# Access Compliance Report

## Public Rights-of-Way

### (Curb Ramps)

Intersection ID: 52442	Main Street: WOODWARD_AV	Cross Street: BENDING_BIRCH_PL	Location: NW
ADA ID: 1B9B9D34B999	Ramp Type: Directional1	Initial Pass/Fail: Fail	Overall Compliance: No
		Severity Score: 50

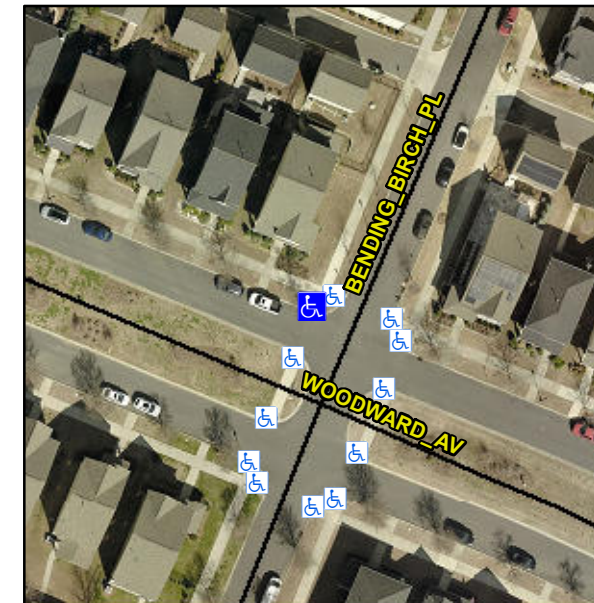
**R304.2.2, R304.5.3**

Compliance	Description	Data	Compliance	Description	Data
N/A	Ramp Length (in)	84.5	N/A	Grade Break?	N/A
Yes	Ramp Width (in)	62.0	N/A	Grade Break Slope (%)	0.0
No	Ramp Slope (%)	14.4	N/A	Grade Break XSlope (%)	0.0
No	Ramp XSlope (%)	7.6			
N/A	Flare Type LT	N/A	N/A	Flare Type RT	N/A
N/A	Flare Slope LT (%)	N/A	N/A	Flare Slope RT (%)	0.0
N/A	Flare Traversable LT?	N/A	N/A	Flare Traversable RT?	N/A
N/A	Landing Length (in)	0.0	N/A	DWS Provided?	N/A
N/A	Landing Width (in)	0.0	N/A	DWS Contrast?	N/A
N/A	Landing Slope (%)	0.0	N/A	DWS Length (in)	N/A
N/A	Landing X Slope (%)	0.0	N/A	DWS Full Width?	N/A
N/A	Landing Curb? (Y/N)	N/A	N/A	DWS Offset LT (in)	N/A
N/A	Shared Landing?	N/A	N/A	DWS Offset RT (in)	N/A
N/A	Gutter Ponding?	0.0	N/A	Gutter Slope (%)	N/A
N/A	Gutter Lip Ht (in)	1.0	N/A	Gutter X Slope (%)	N/A
N/A	Painted X Walk1?	No		Road Slope (%)	1.8
	X Walk 1 Direction	To S		Road X Slope (%)	7.1
	X Walk 1 Width (in)	N/A		Clear Space?	N/A

X Walk 1 Slope (%)	1.8	N/A	Clear Space to XWalk (in)	N/A
	X Walk 1 X Slope (%)	7.1	N/A	Storm Grate/Utility Hazard?	N/A
N/A	Ramp inside XWalk1?	N/A		Storm Grate/Utility Type	
N/A	Any Obstructions?	N/A			N/A
	Obstruction Type		Yes	Surface Condition? (G/P)	Good
			N/A	Curb Slope (%)	4.7

**Remove & Replace Entire Ramp.**
